Re: Draft Environmental Impact Report for the South Bay Substation Relocation Project, Chula Vista, California

The San Diego National Wildlife Refuge Complex (Complex) has reviewed the draft Environmental Impact Report (EIR) for the South Bay Substation Relocation Project located in Chula Vista, California. We offer the following comments for your consideration.

Figure D-1: AIS Substation Detailed Project Components Map 1 of 3

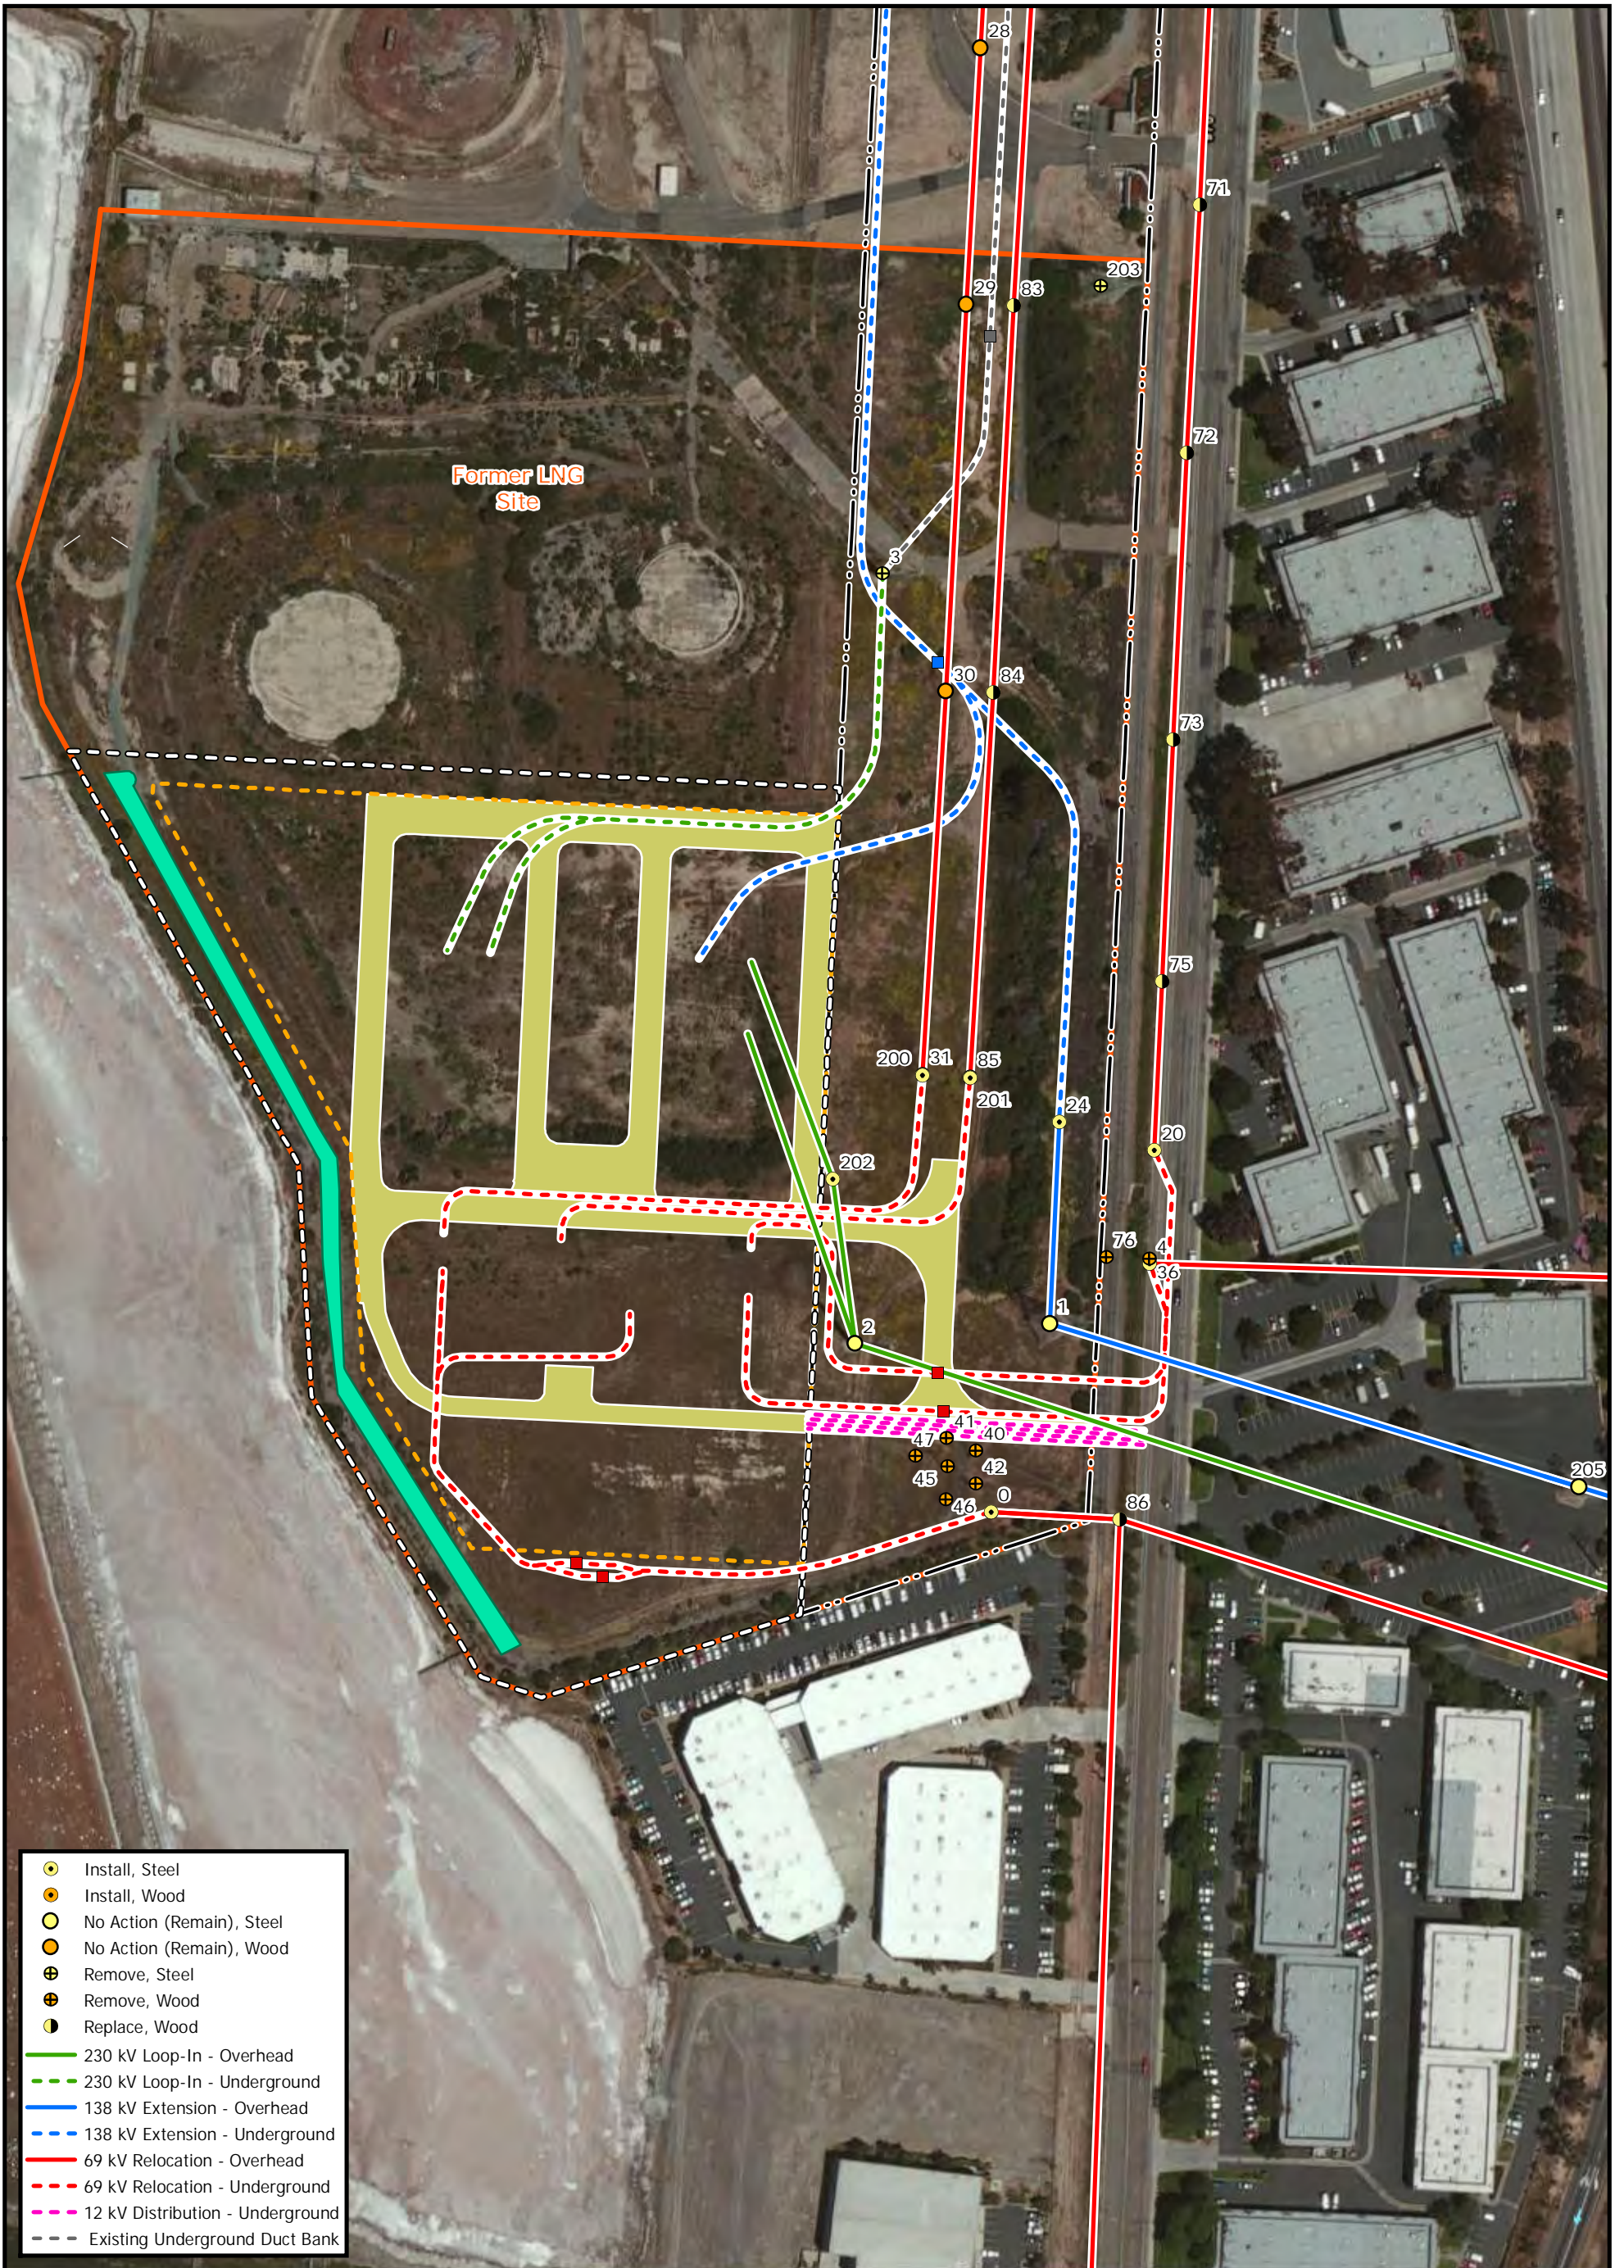
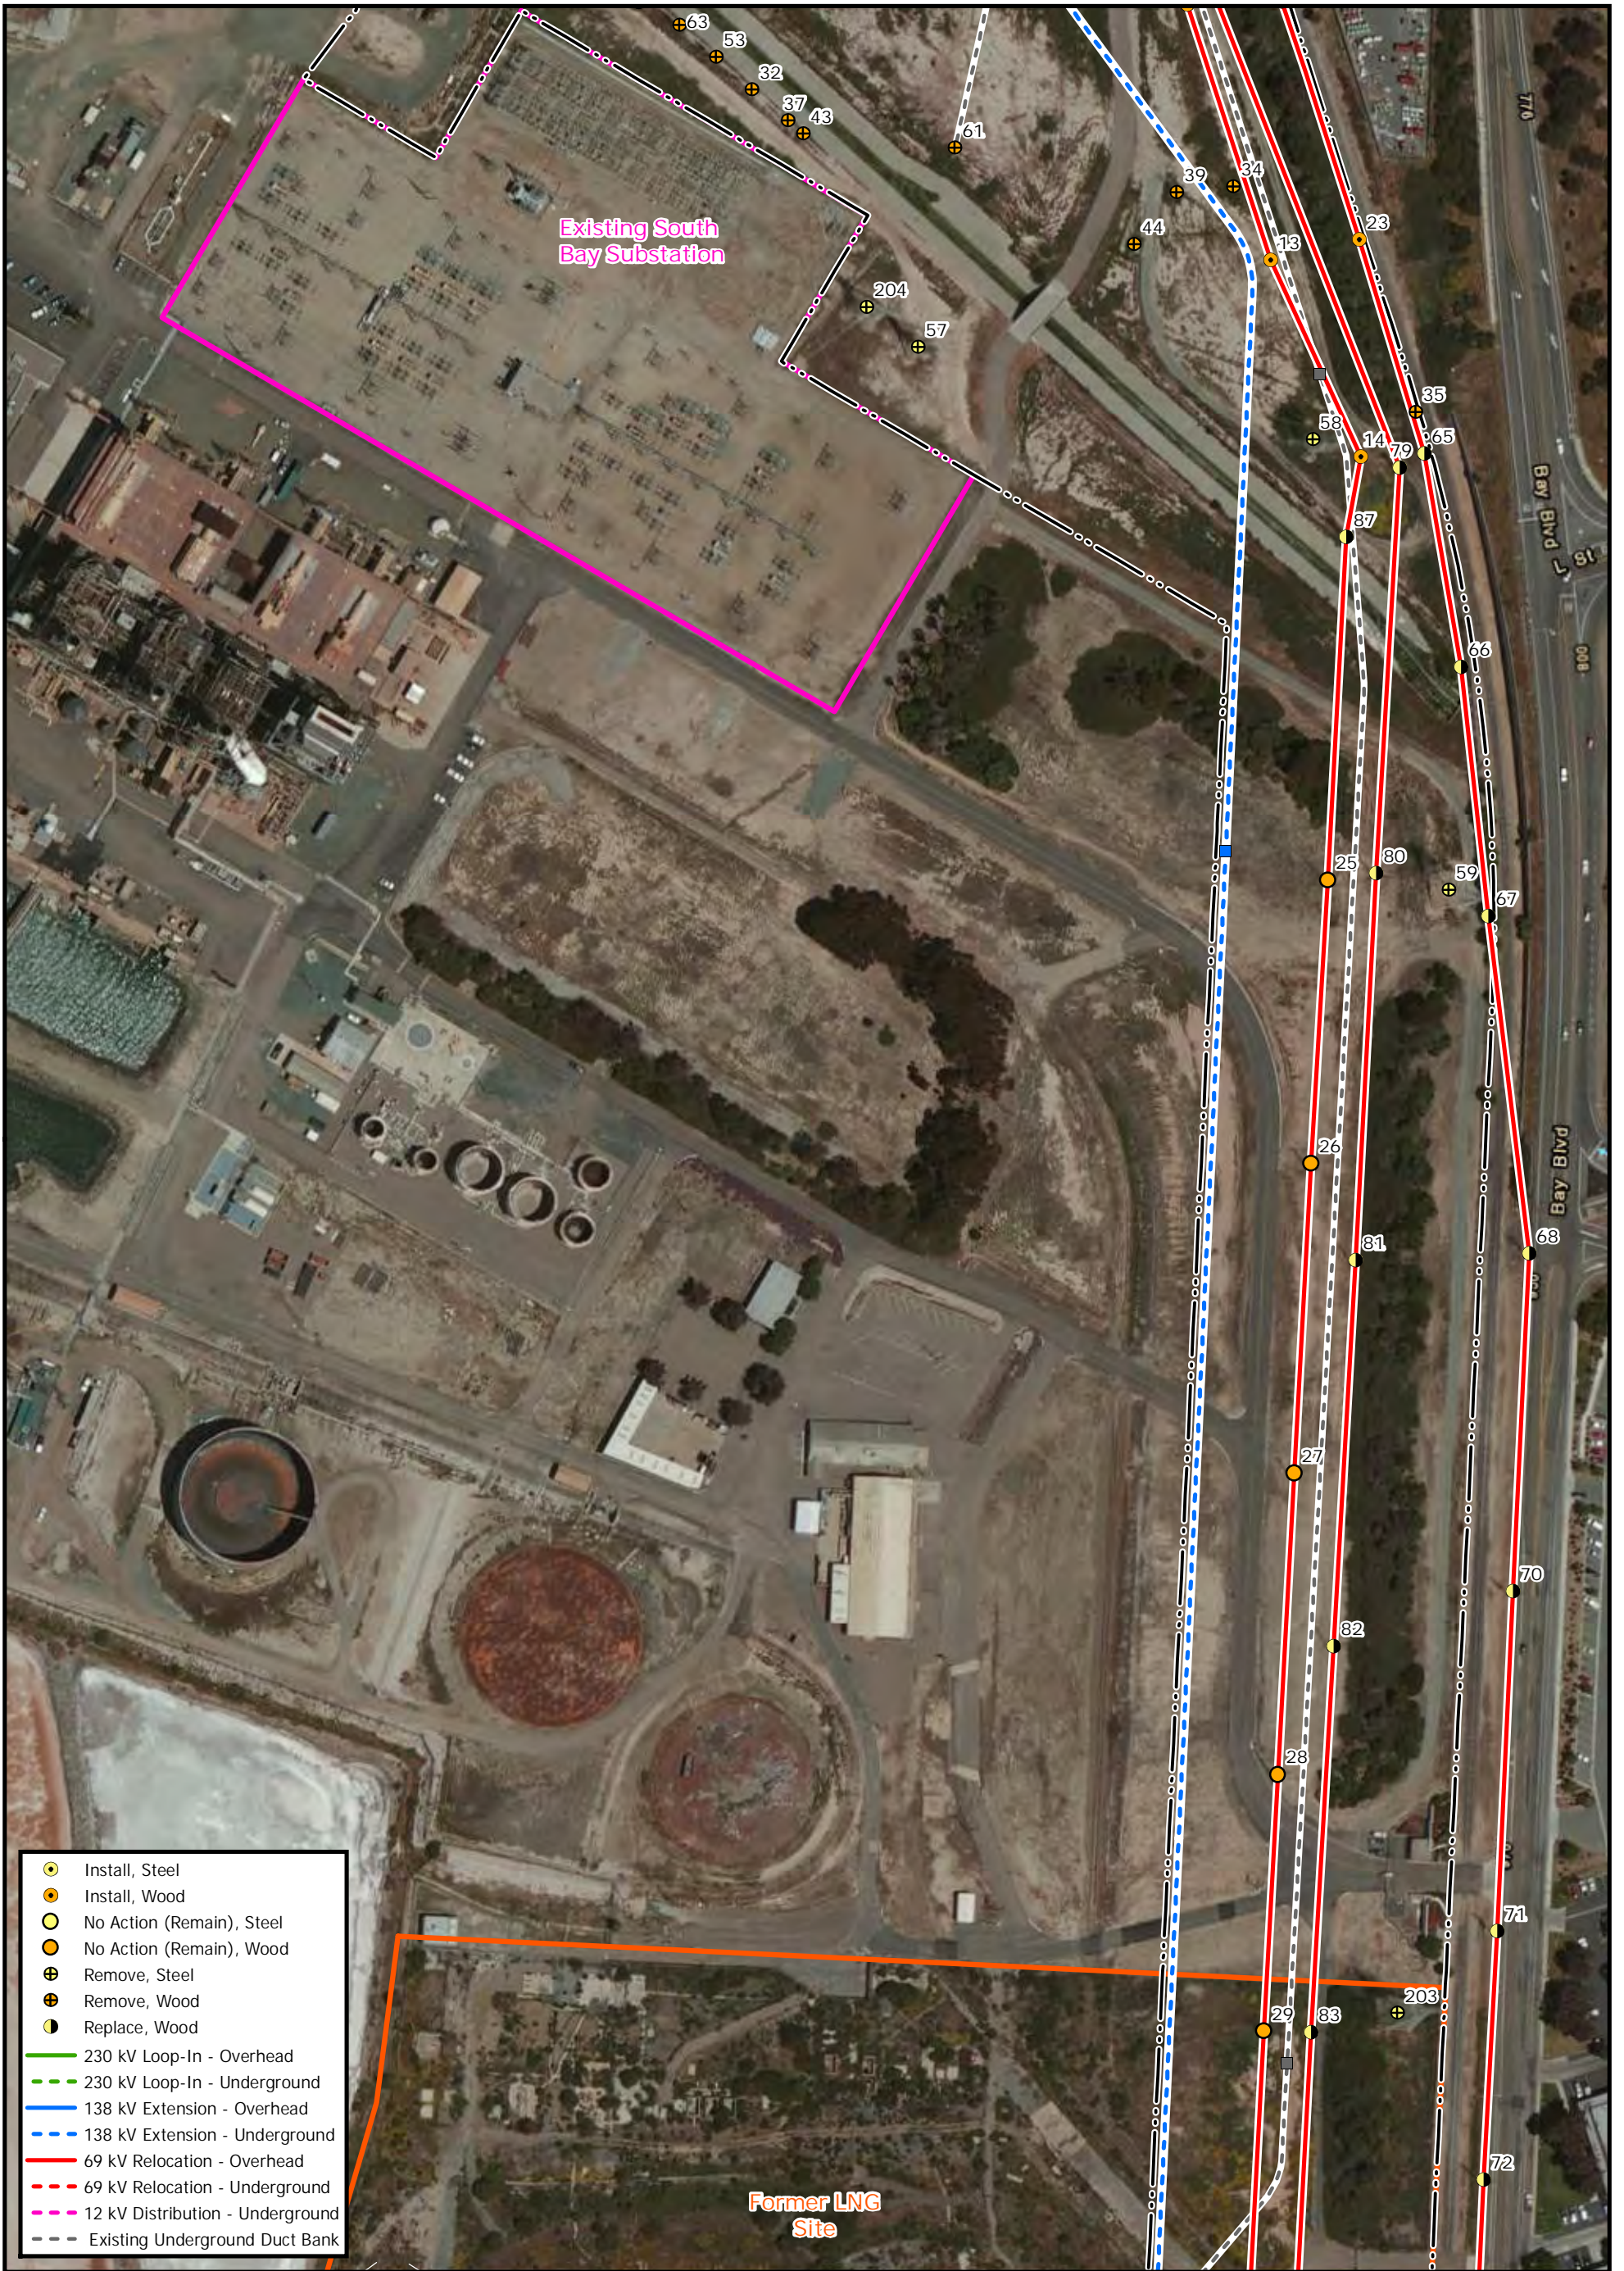
4.	General	General	NA	The figures in this document that depict the Proposed Project components should be revised to display the overhead transmission lines. In addition, the 12 kilovolt (kV) distribution line is shown entering the proposed substation, although the figures should depict the line from the 69 kV riser poles to the substation as underground 69 kV transmission line, rather than 12 kV distribution line. Each of the figures depicting the Proposed Project components in the EIR should be revised in accordance with Figure D-1: AIS Substation Detailed Project Components Map, which was previously provided in the PEA.

26.	B-7	Figure B-3	NA	As previously described in Comment #4, the overhead portions of the 69 kV and 138 kV lines are not shown in the figure. However, the figure shows the 12 kV underbuild associated with TL644 proceeding into the proposed substation. The 12 kV underbuild does not extend into the substation. The portion of the line extending from the 69 kV riser poles into the substation should be revised in accordance with Figure D-1: AIS Substation Detailed Project Components Map to show the 69 kV underground line (dashed gold lines, as provided in the legend) for the section between the riser poles and the substation, which was originally provided in the PEA.

27.	B-9	Figures B-3a, B-3b, and B-3c	NA	Figures B-3a, b, and c should be revised in accordance with Figure D-1: AIS Substation Detailed Project Components Map, which was originally provided in the PEA. The following items were identified as being in need of revision: <ul style="list-style-type: none"> • The overhead portions of the 69 kV and 138 kV lines are not shown in the figure, while the 12 kV overhead line is depicted. • The callout box for the 230 kV Steel Cable Riser Pole should be revised to read “230 kV Steel Angle Pole (proposed).” • The underground getaways for the 69 kV are not depicted correctly in Figure B-3a. As discussed in the previous comment, the blue lines going into the substation should be shown as dashed orange lines between the substation and the 69 kV riser poles, per the figure legend. • The substation’s internal road layout should be updated to reflect that provided in Figure D-1: AIS Substation Detailed Project Components Map, which was originally provided in the PEA.

112.	D.10-3	Figure D.10-1	NA	Only the 230 kV overhead lines are shown in the figure. The 138 kV and 69 kV lines should also be displayed, as provided in Figure D-1: AIS Substation Detailed Project Components Map, which was originally provided in the PEA.
